DEPARTMENT OF GENERAL SERVICES
BUREAU OF CAPITAL PROJECT DESIGN MANAGEMENT
1800 HERR STREET
HARRISBURG, PENNSYLVANIA

ADDENDUM NO. 10

PROJECT NO. DGS C-1576-0010 PHASE 001
PROJECT TITLE - SCI Frackville - Electrical Upgrades

CONSTRUCTION DETAILS
DRAWN BY D. ATKINSON DATE 09/15/23 DRAWING No. C6.1
CHECKED BY J. STACHOKUS SCALE AS NOTED

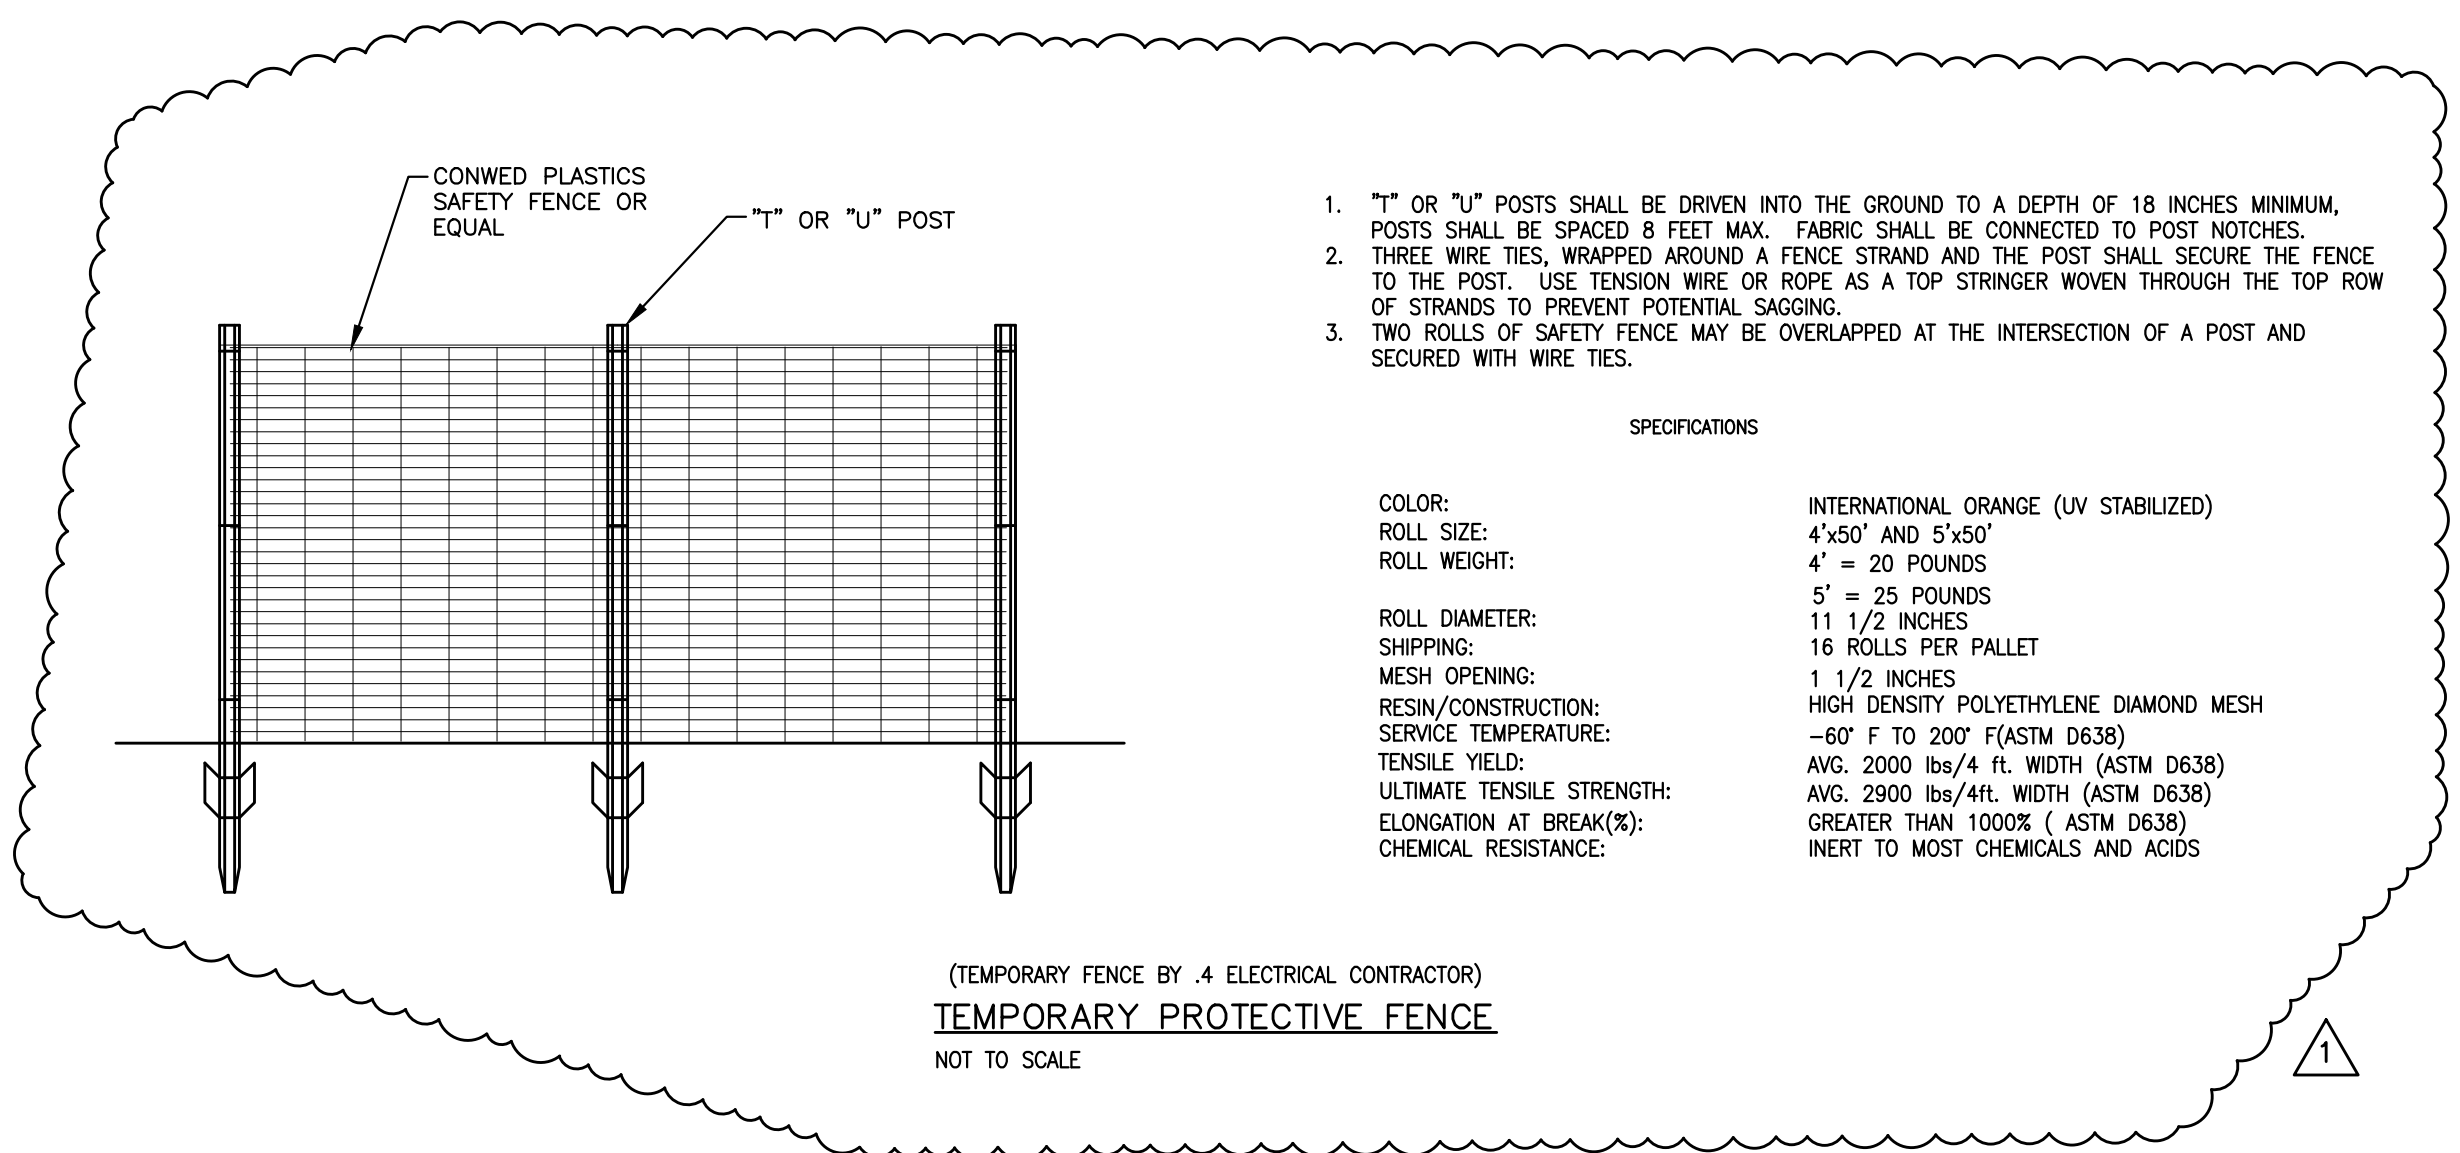
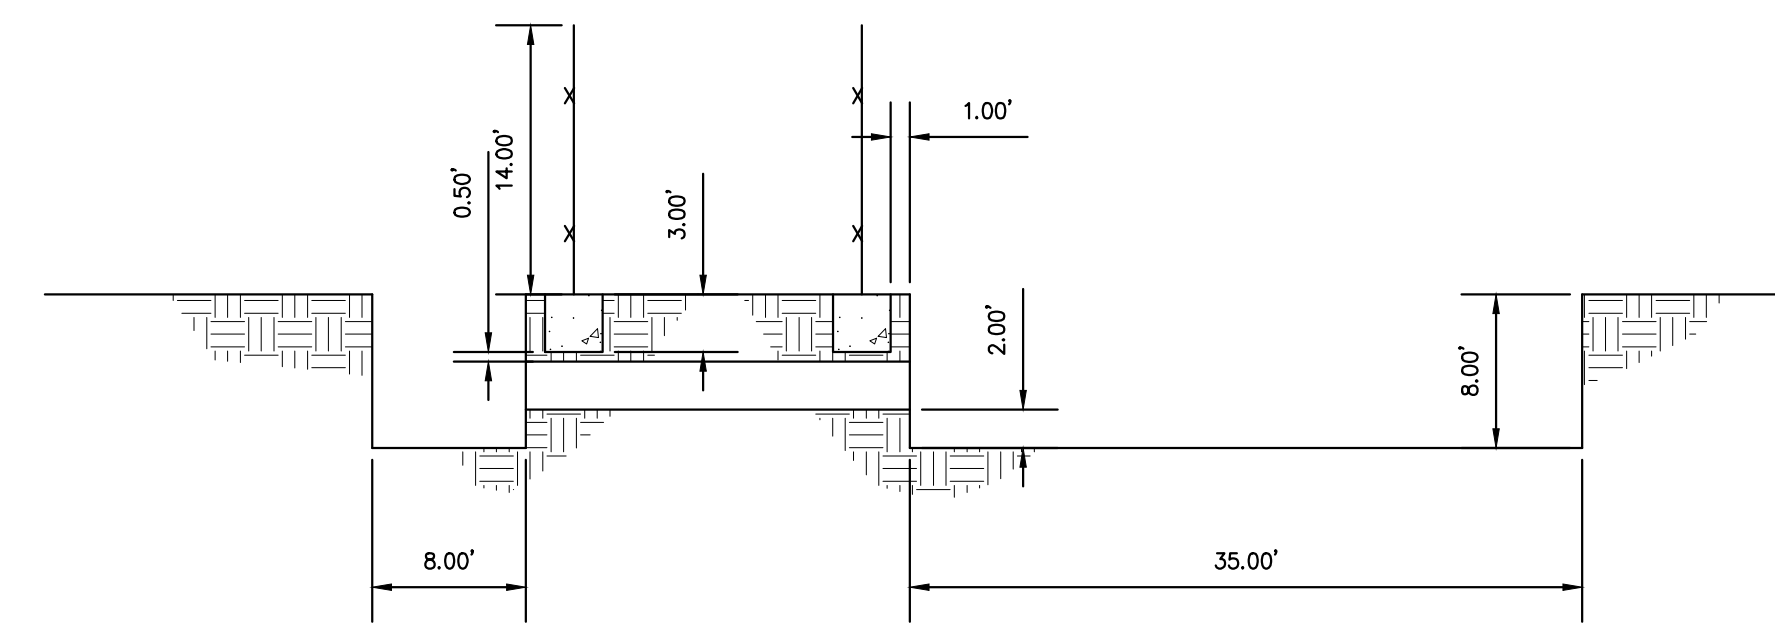
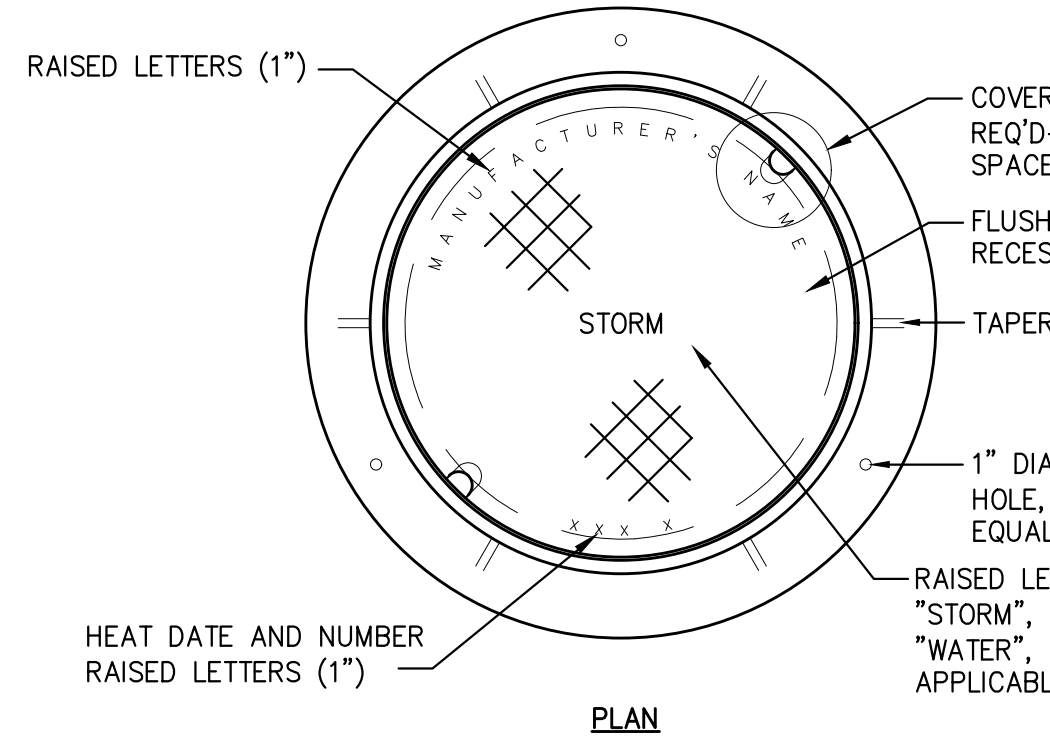
Item 3 - C6.1 – Added note to temporary fence detail to include “TEMPORARY FENCE BY .4 ELECTRICAL CONTRACTOR”.
